Construction Division
Additions & Alteration Charges Approval Form

Company Name:	MRMLLP	Site	Gulmohar Residency
Name of the customer	Ram Prasad Atturi		
Flat No.	D-608

GULMOHAR RESIDENCY

Details of Additions & Alterations

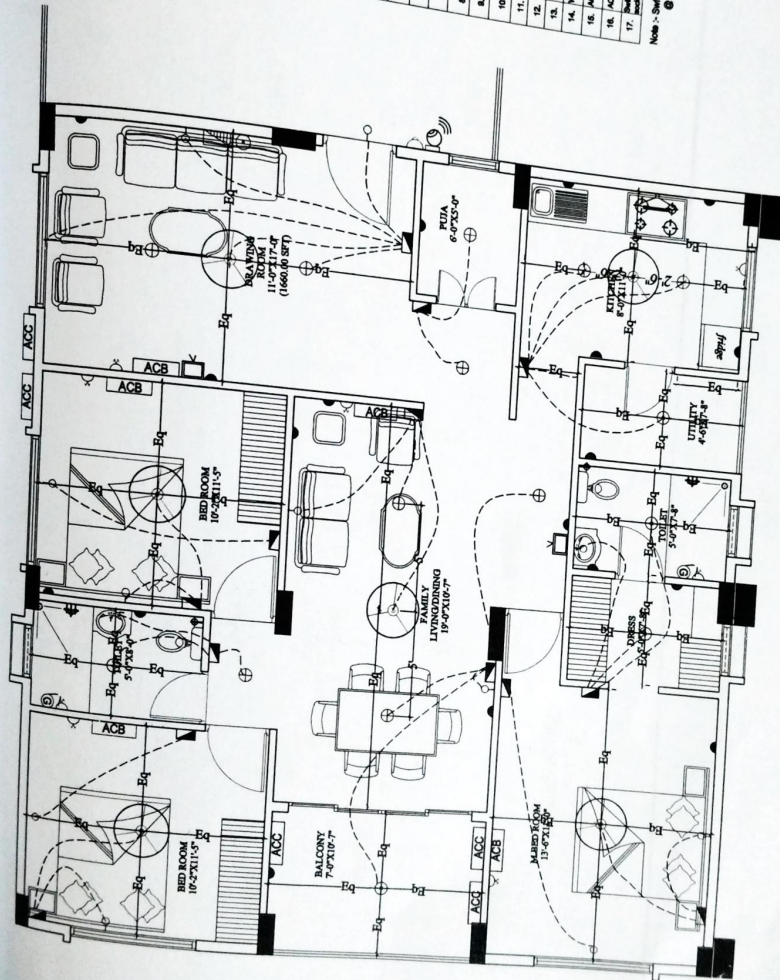
Changes in flooring:

① flooring tiles, laying by Customer
itself

Changes in electrical points: (mark on plan)

① Electrical points high. problem as per
Customer Request.

Choice of Bathroom tiles, CP fittings & Sanitary ware:

1) Both Bathroom going for Granite soft
Door frame not Required for Both Bathrooms.
